DEVELOPMENT and PLANNING SERVICES COMMITTEE

May 15, 2017

Subject: Zoning Bylaw Amendment Application No. 1090

Subject: **Development Variance Permit Application No. VP-454**
(Parcel Line Setback)

BC LAND SURVEYOR'S BUILDING LOCATION CERTIFICATE

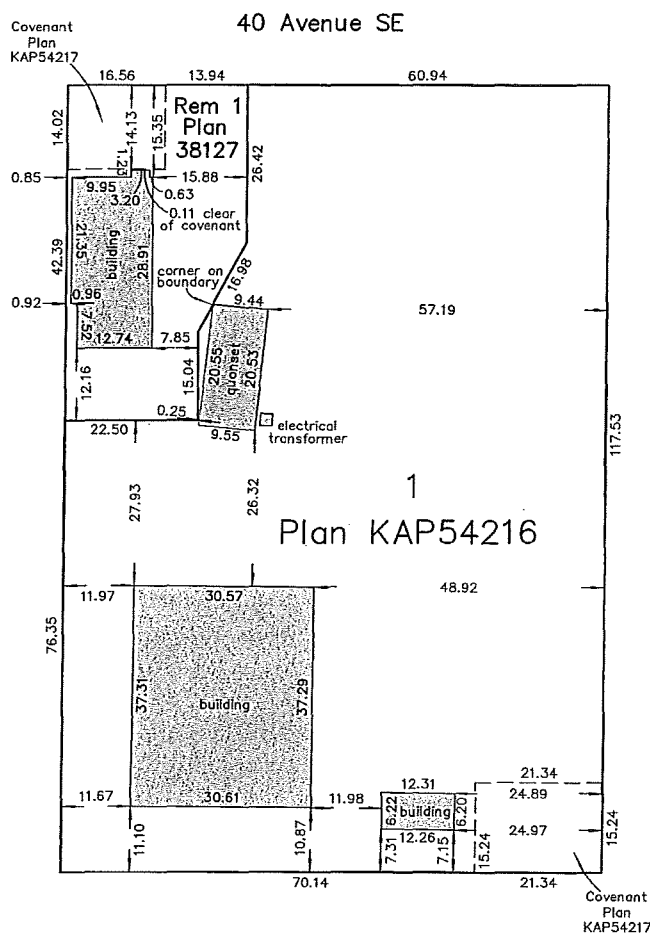
Section 28.8.3 – M-1 General Industrial Zone - reduce the parcel line setback from 4.0 metres to 0 metres along a portion of the western parcel line to allow for an accessory building, as shown in Schedule A.

Setback regulations better ensure adequate separation between buildings sited on adjoining property for aesthetic, privacy, view preservation and fire safety reasons. The requested variance from the parcel line requirement for the accessory building translates into a reduction of 4.0 m (a zero parcel line setback).

Remaining consistent with previous and similar variance applications, staff does not recommend approval of this application. The main reasons being:

- the magnitude of the requested variance (reducing the minimum 4.0 m setback to zero);
- the ability to shift a tent structure;
- the potential option of adjusting the parcel boundary;
- that approval of the variance could lead to similar expectations by other land owners; and
- that such variances can inequitably burden adjacent properties.

If approved, Development Variance Permit No. VP-454 will only be applicable to a development plan indicating the setback variances, as shown in Schedule A (Appendix 3).

PAGE **DP-3**

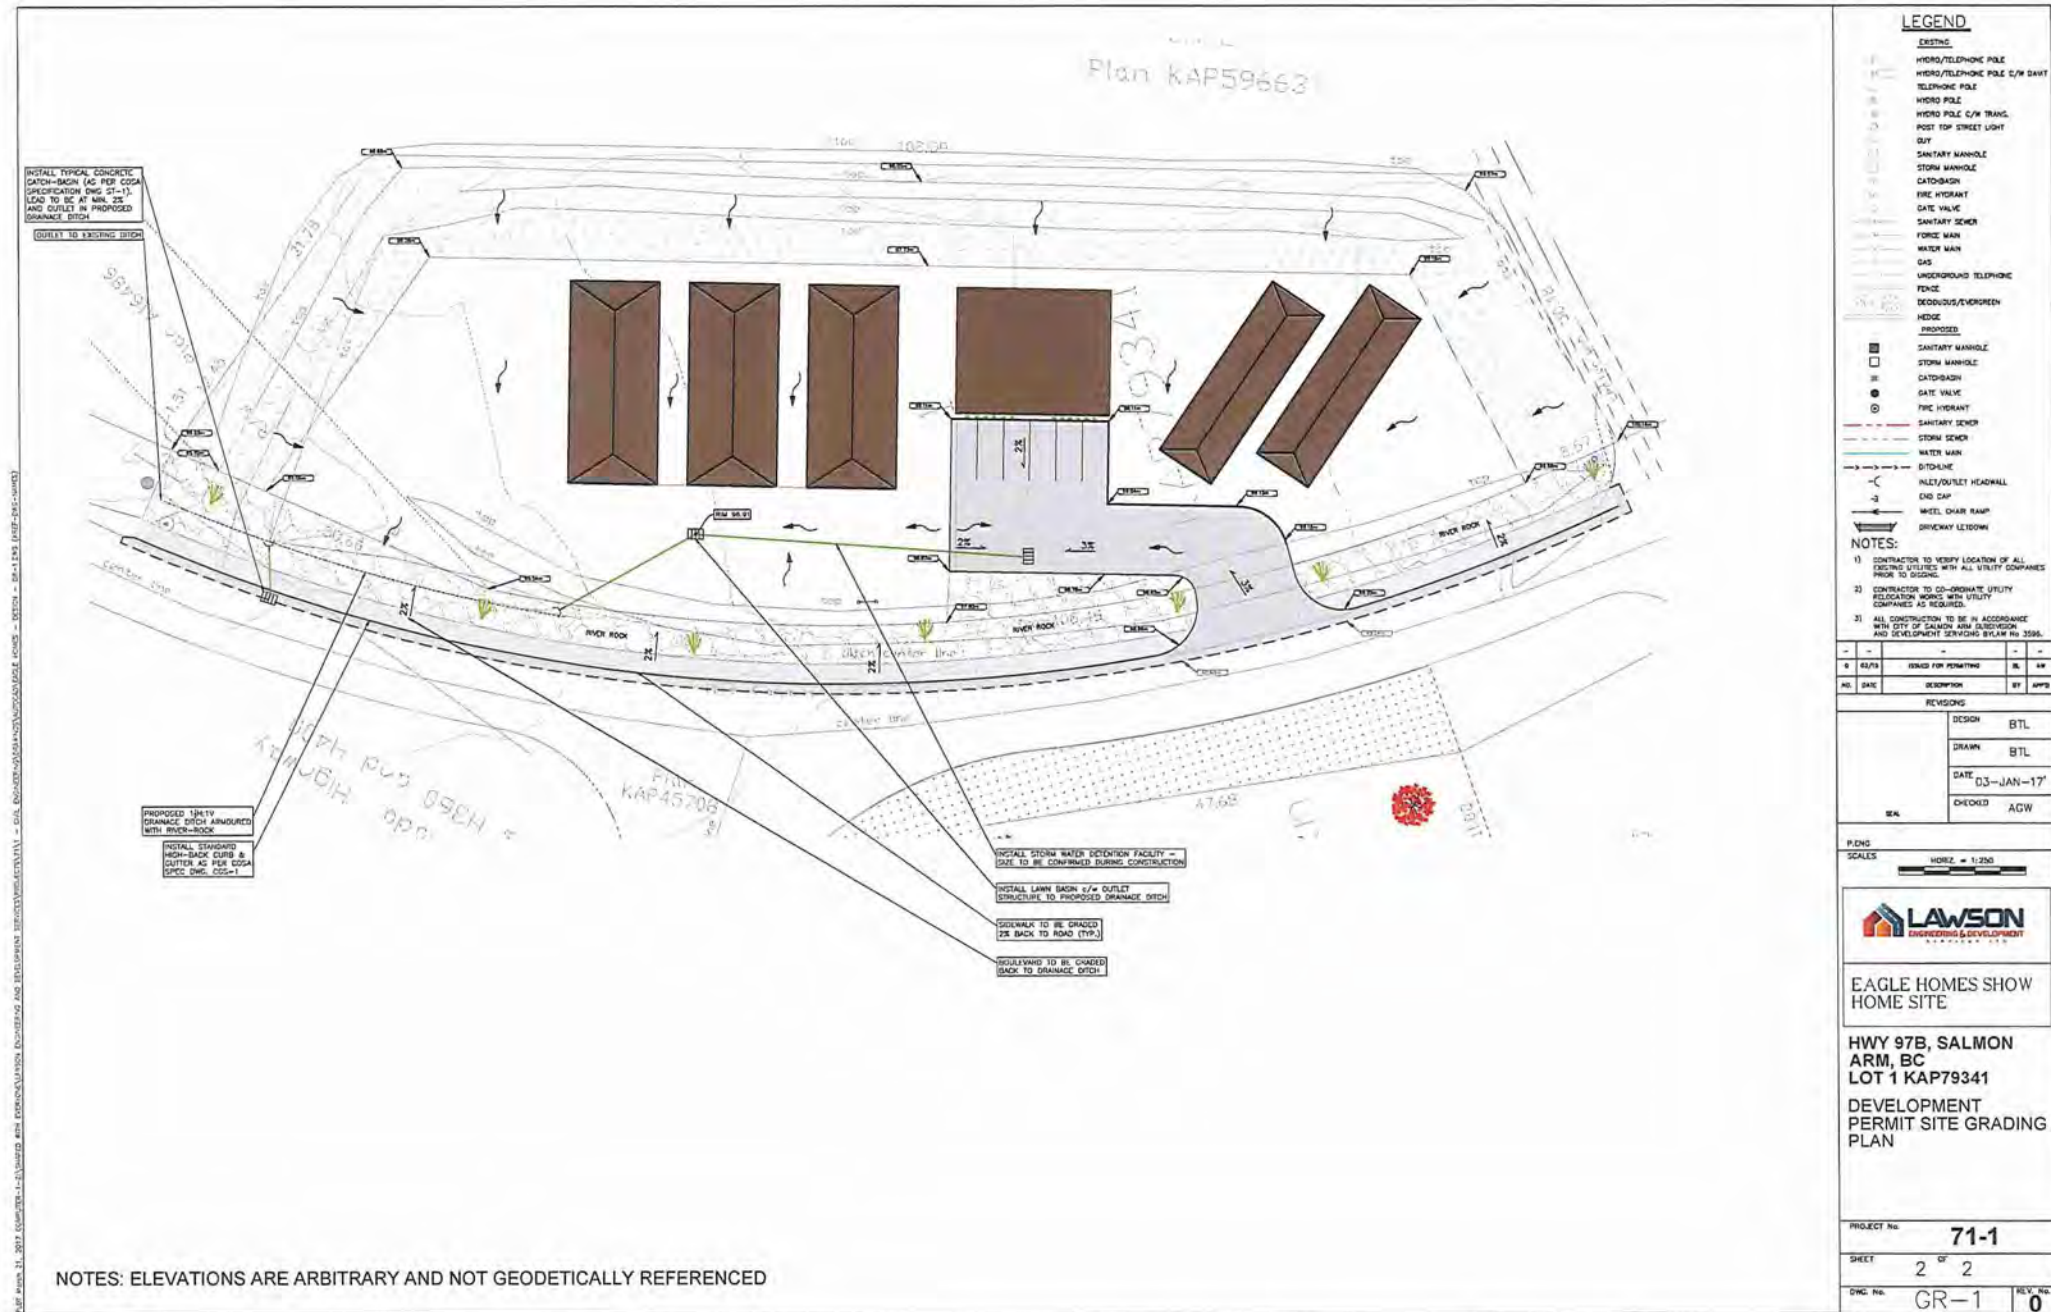
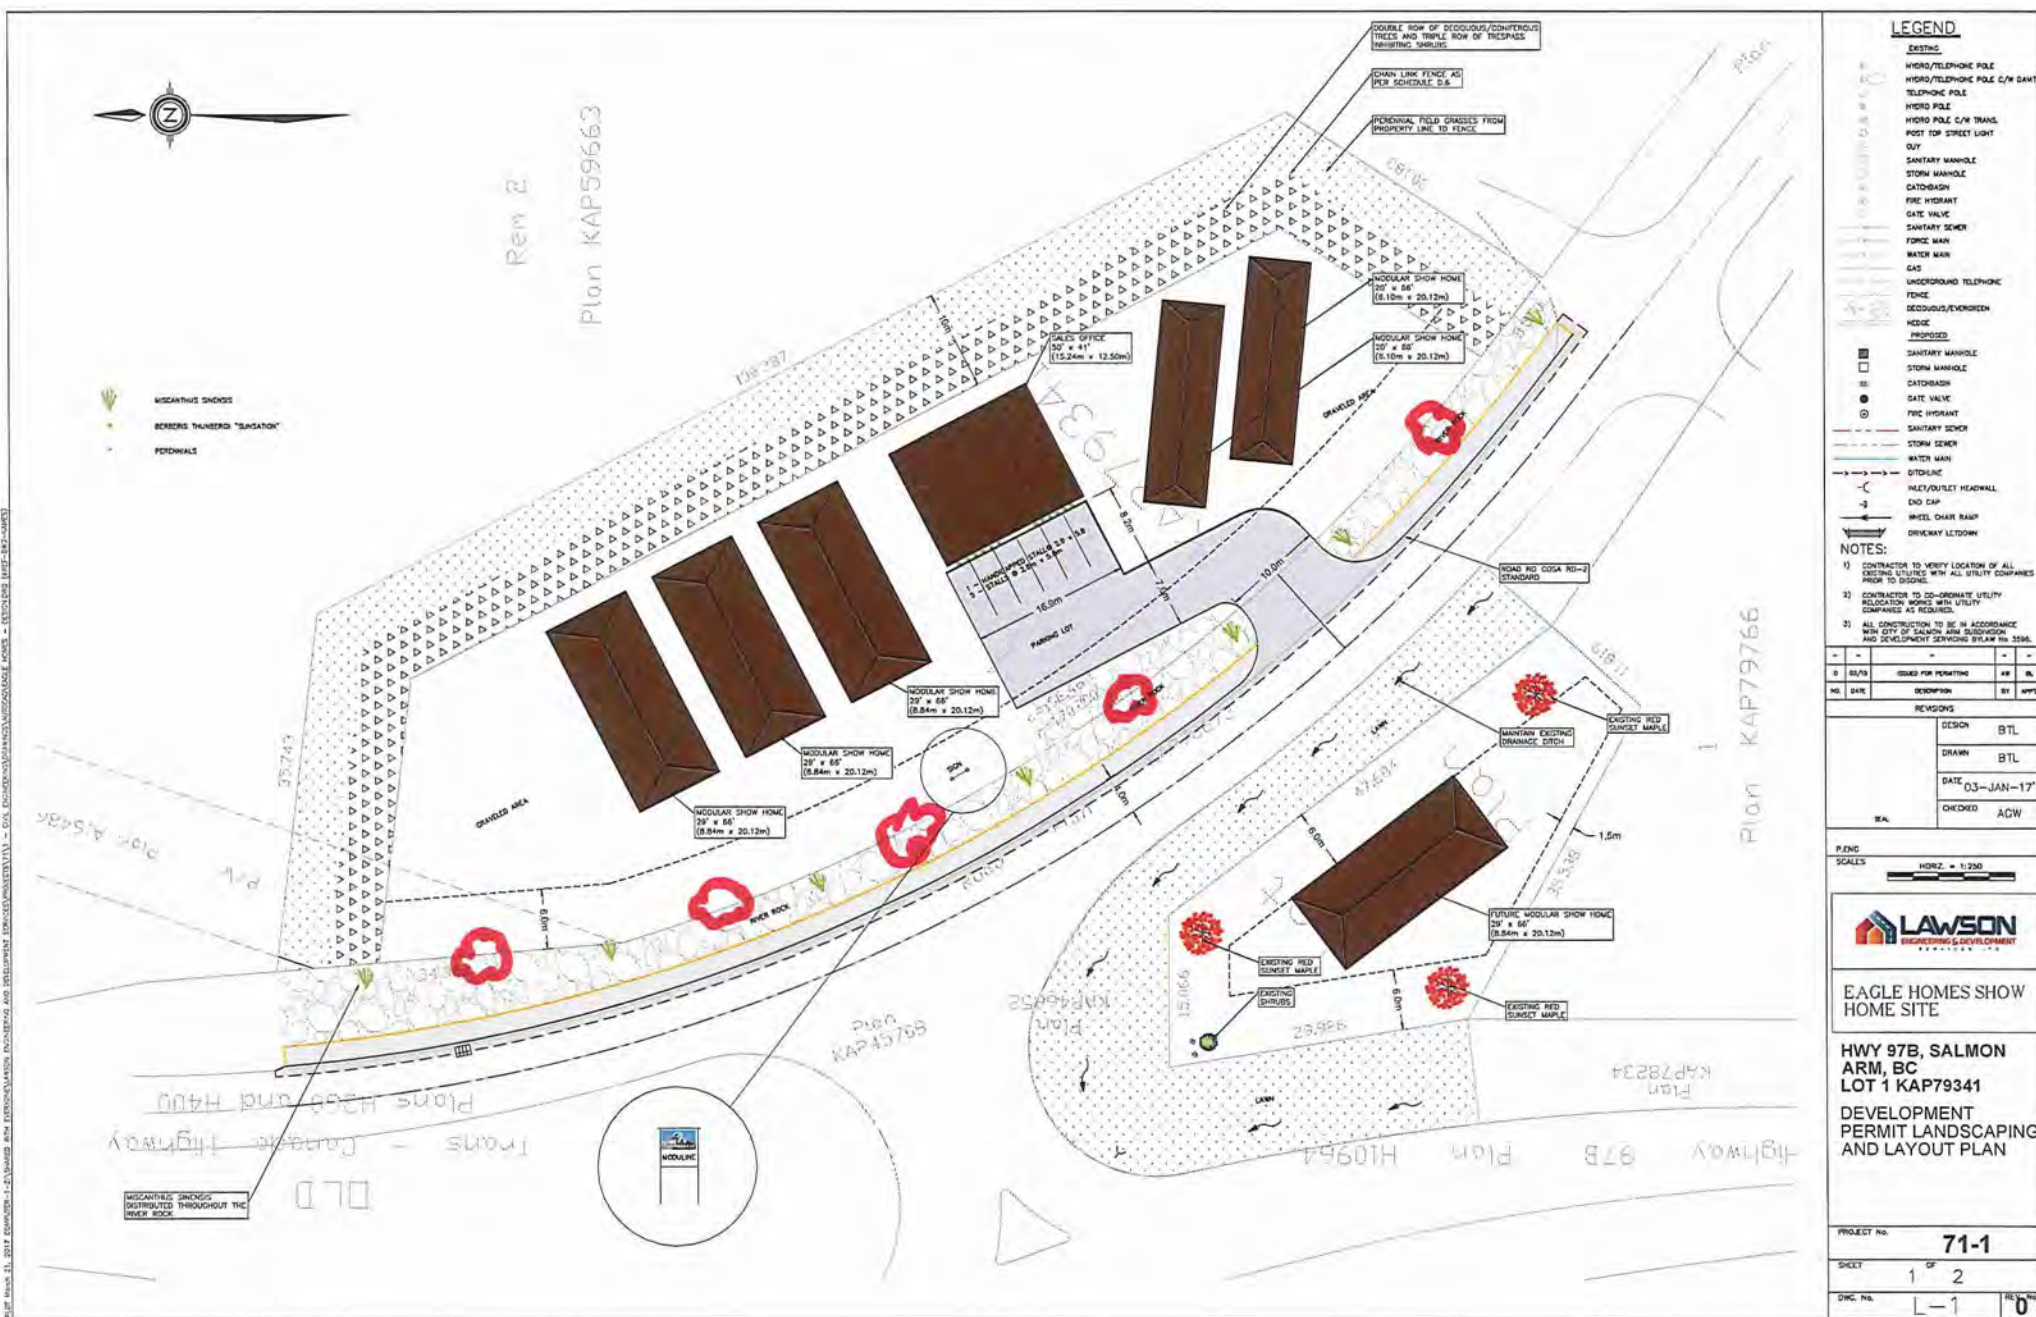
- encouraging the incorporation of high-end building finishes (stone and fibre cement siding).

The DRP noted the lack of detail in the elevation drawings provided with respect to building finishing materials and the ALR landscaping, and encourage inclusion of this information in future applications.
